A-4-MRA-19-0034 / 9-19-0918

California-American Water

California American Water Peer Review of August 20, 2020 Letter from M1W to CCC

Prepared By: Kevin Alexander, P.E. Hazen and Sawyer - August 23, 2020

Updated Figure 3: Reduced Demand = Reduced WWTP Flow (=Reduced Recycled Water Supply)

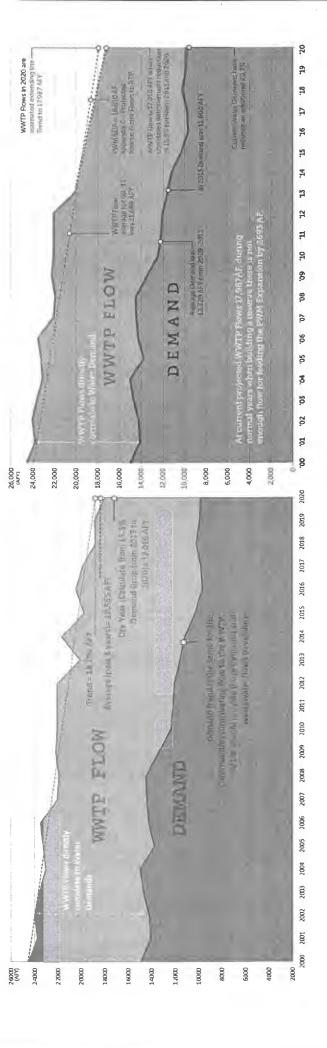
Sawyer's August 11 Memorandum have been updated below to account for the revised average flow of 18,555 AFY using the last 3 years of data. Even based on this updated information, Hazen's prior conclusions remain valid and it is evident that there is not enough wastewater flow to support the PWM Phase One and the PWM Expansion as a reliable source of water supply for the Peninsula. In particular, there will be deficits over the summer months – particularly in dry years – given the existing commitments of source waters that are proposed for PWM Phase One and PWM Expansion. M1W has not provided any evidence to counter these real deficits or explain how they can be avoided.

- The deficits that Hazen has demonstrated using M1W's own updated numbers – show that there is not sufficient source water for PWM Phase One and PWM Expansion to produce their promised product water to CalAm's customers of 3,500 AFY and 2,250 AFY, respectively.
- In addition, M1W has provided no evidence that Hazen's projections of reduced Reclamation Ditch flows are incorrect. Even though Hazen has serious concerns with the amount of other surface water flows from other sources purportedly available to the PWM Expansion, Hazen conservatively only made reductions as to Reclamation Ditch flows because there was publicly available evidence from USGS that Reclamation Ditch flows were lower than presented in the SEIR.

Figure 2: Monterey Peninsula Water Supplies to Meet Demands

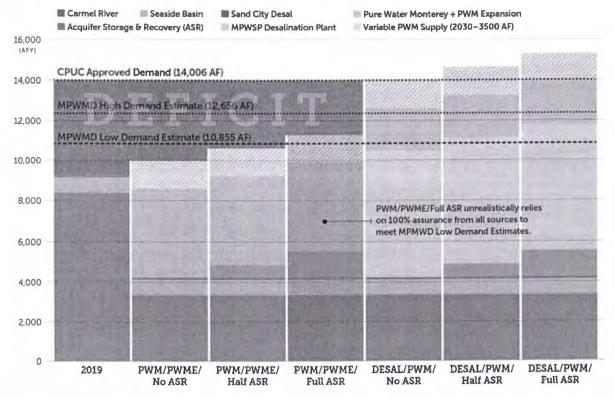
In addition, counting on ASR storage at 100% with limited knowledge of losses to the ocean and other basins imparts uncertainty in that supply as a continuous resource and drought mitigation strategy. In Figure 2 below, ASR volume is shown under three distinct scenarios to account for the limited volume stored over the past 15 years and these other uncertainties—No ASR, Half ASR and Full ASR. Notably, even the Half ASR scenario requires 650 AFY, which is almost double the average ASR availability over the past five years, and over five times the 15-year ASR average. When the variability of ASR is considered, the PWM Phase One and PWM Expansion do not meet the Peninsula's minimum water demands. This is one of the reasons that the California Public Utilities Commission concluded that "only in conjunction with construction of a desalination plant of some size within five to fifteen years" would the PWM Expansion be capable of providing a "sufficient and reliable water supply" for the Peninsula. (See CPUC Decision D.18-09-017, Appx. C, p. C-71.)

MPWSP opponents claim that the MPWSP is not currently needed to meet existing demand projections. However, meeting even the lowest demand projections without the MPWSP requires full capacity operation of two other supplies that have yet to prove reliable and are vulnerable to high-probability risks.

Figure 3: Reduced Demand = Reduced WWTP Flow (=Reduced Recycled Water Supply)

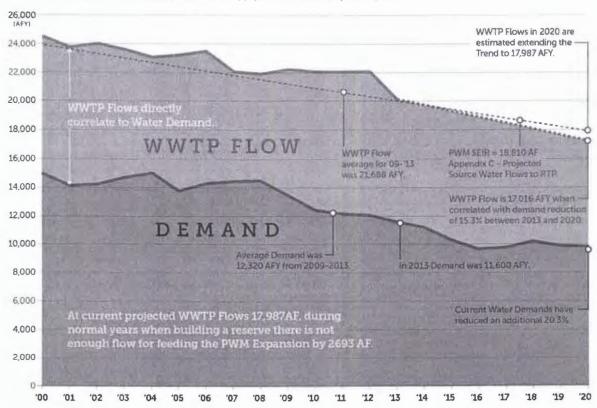
The approach taken in Appendix I ignores that WWTP flows correlate to water demand/use, which has continued to decrease on the Peninsula due to conservation and other factors. Based on available data, Figure 3 below depicts an overall downward trend in WWTP flows that is consistent with the observed decline in water demand on the Peninsula. The EIR from 2016 for PWM Phase One shows WWTP flows trending downward from approximately 25,000 AF in 2000 to approximately 20,000 AF in 2013.8 A separate appendix to the Supplemental EIR (Appendix E) shows further reduced WWTP flows to 18,810 AF (16.79 MGD).9 However, this number was not utilized in the Supplemental EIR to calculate available WWTP flows as source water for either PWM Phase One or PWM Expansion, which is a significant error.

Figure 3 shows that the WWTP Flows correlate with demand reductions on the Peninsula. For example, as shown in Figure 3, since 2013 demand has declined 20.3% when compared to the average demand from 2009 to 2013. Additionally, 2013 drought year demand compared to current demand, represents a 15.3% reduction. Calculating the WWTP flows over these same time periods using these respective reduction percentages (20.3% and 15.3%), a conservative estimate of current average WWTP flows is 17,296 AF to as low as 17,016 AF, respectively. An alternative method of determining todays WWTP flows based on a linear trend of the existing flow data indicates that current flows are 17,987 AF, as shown in Figure 3. All of these WWTP flow estimates, which are based on a more complete picture of recent data, are much lower than those used in the SEIR Appendix I -Tables 8 to 11. As result the SEIR substantially overstates the availability of WWTP flows available as source water available to PWM Phase One and the PWM Expansion.

Monterey Wastewater Flows shown in the SEIR Appendix I-Table 8,9,10 (Normal Yr) and Table 11(Dry Yr) use data from 2009-2013 which does not represent the current WWTP Flows. The graph below estimates current WWTP flows in 2020 based on demand correlation from MPWMD Supply and Demand Report-Fig 1.

Figure 4: Impacts of Demands Exceeding Limited Supplies

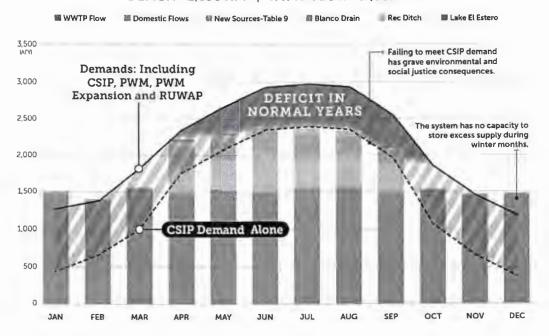
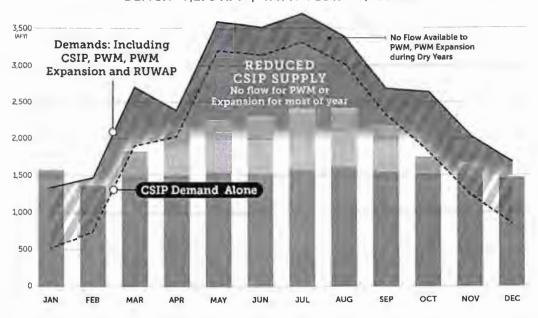
The combined analysis of supplies and demand illustrated in Figure 4 below (Normal/ Wet Year Building ASR) and (Dry Year) are based on monthly supply and demand from SEIR Appendix I-Tables 9 and 11 with data updated as noted in Table 1 above. Figure 4 shows that when lower WWTP Flow from Figure 3 and lower Reclamation Ditch flows from Table 3 and all other available sources are accounted for, that demand for those specific source waters far exceeds available supplies in Normal/Wet Years and in Dry Years.

The demand assumptions in Figure 4 use the same values in SEIR Appendix I Tables 9 and 11 for CSIP, PWM Phase One, PWM Expansion and RUWAP which are the same values used in Table 1 above.

As shown in Figure 4 above there is a demonstrable water deficit. Monthly supply of water as compared to demand even when the additional proposed supplies of Agricultural Wash Water, Urban Runoff, Blanco Drain, and Reclamation Ditch are included does not satisfy the demand during a significant portion of the year – particularly during the summer months.

Figure 5: Supply Available for PWM Expansion or CSIP (Not Both)

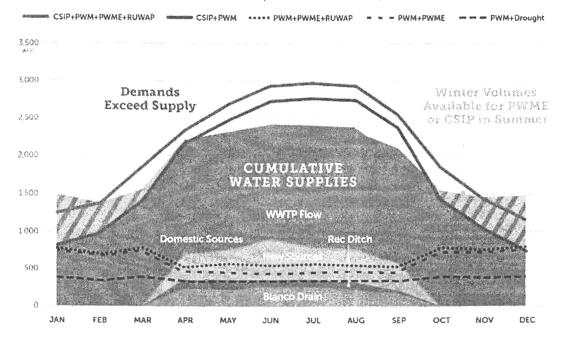
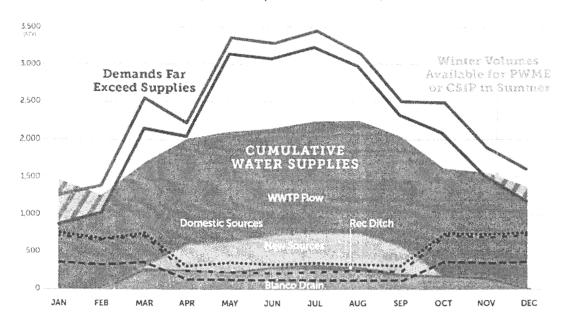
Figure 5 closely correlates the cumulative water supplies to the respective cumulative demands. The water supplies are shown in the order of use with the PWM Phase One using Blanco Drain and Rec Ditch. Based on agreements, such as the Amended and Restated Water Recycling Agreement between the M1W and the Monterey County Water Resources Agency, those flows are unavailable to the PWM Expansion. Then New Sources are added to serve as the supplies for the PWM Expansion according to the priorities and water rights as defined in SEIR Appendix M. The supplies are cumulative by month. The graphs are based on SEIR Appendix I -Table 9 and 11 with the WWTP and Reclamation Ditch flows updated. These graphs include Lake El Estero and AWW, which are now not included in the water supply as noted in SEIR Appendix M as a best-case supply scenario (SEIR Appendix M-Page 5).

The demands in Figure 5 are each shown cumulatively for PWM, then PWM+PWME, then PWM+PWME+RUWAP, and ultimately PWM+PWM+RUWAP and CSIP. There is a separate blue line of PWM+CSIP to show a normal year today without the PWM Expansion. That line is necessary to determine available volume in the winter.

Figure 5 demonstrates that in normal years, excess winter effluent that would ultimately go to the Ocean can be used or it is otherwise wasted. However, with current CSIP demand the system will always be in a deficit. If CSIP could capture winter flow (such as the proposed but not implemented improvements to the Salinas Valley Reclamation Project (SVRP) (SEIR Master Response #3 p. 3-20, SEIR Appendix M- Page 5)) to run SVRP and CSIP at lower flows without using wells in conjunction with water storage or groundwater infiltration, then excess winter water could be available for use in the summer for CSIP. Implementing such a storage program would be a sizable new development project and would require a significant investment to secure and develop the necessary property where the storage program could be implemented (such as a reservoir). Further, for CSIP and CSIP well demands in SEIR Appendix I Tables 9-11 to be met, this would require all of the other New Water sources, Blanco Drain and Reclamation Ditch as well to meet the combined CSIP and CSIP well flows now and especially in dry years.

CSIP flows are shown in Figure 5 based on the SEIR Tables 8-11 including the CSIP well pumping. It should be noted that the improvements to SVRP have not been completed and therefore, the CSIP must rely on well pumping.

Figure 6: Aquifer Storage and Recovery

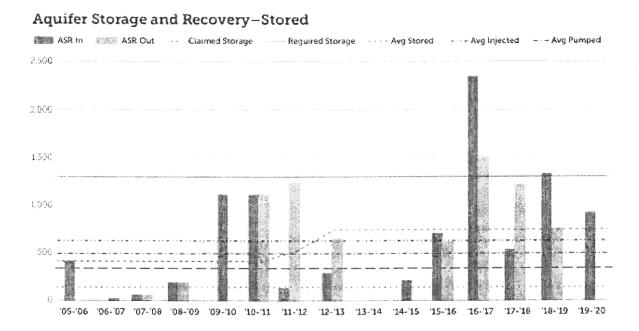
ASR build-up in particular has not been successfully demonstrated throughout the development and use of the ASR system over a 15-year period. As shown in Figure 6, included in the Appendix hereto, only once in the past 15 years has ASR achieved 1,300 AFY. As explained in Hazen's prior memo, ASR water availability is reduced to 63% in a single dry year, and even further reduced to 4% following three dry years. Therefore, ASR does not meet Water Code reliability standards (5 consecutive historic driest years) or Governor Newsom's 2020 Water Resilience Portfolio that requires consideration of a drought lasting six years.

Figure 6 represents the current Aquifer Storage and Recovery program over the past 15 years in operation. Figure 4 shows the average annual injected and annual average pumped volume. The average stored volume annually over 15 years is 138 acre-ft. Over 15 years there is only 700 acre-ft claimed as storage yet the MPMWD Supply and Demand Report indicates they can store 1,300 acre-ft per year. There are only two years the system has achieved more than 1,300 acre-ft into the aquifer. The limited average storage coupled with the injection limitations being experienced at PWM Phase One means these supplies are not yet reliable to be considered as a source that CalAm or any other public agency.

Figure 7: Supply Deficit - SEIR Appendix I - Updated Table 8

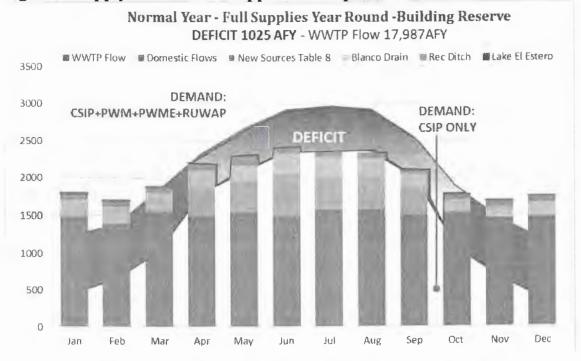
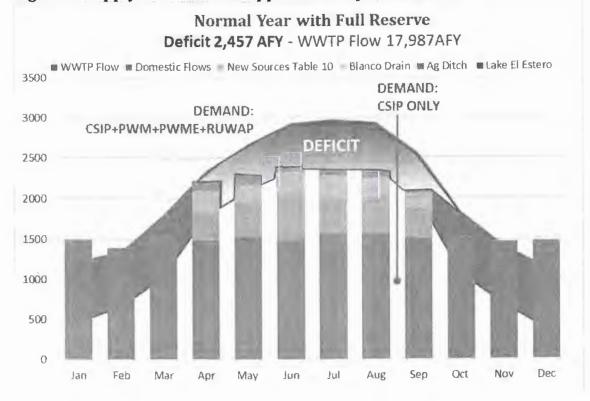
Figures 7 and 8 are provided as further information for Updated Tables 8 and 10 to highlight that in all conditions, there is a flow deficit with updated WWTP and Reclamation Ditch Flows. In the above document, Best Case and Worst Case were used to keep the discussion simple and direct. There is a flow deficit in all conditions and there is a need to update the relevant calculations with recent flow data to give an accurate assessment of supply and demand in a clear and transparent way.
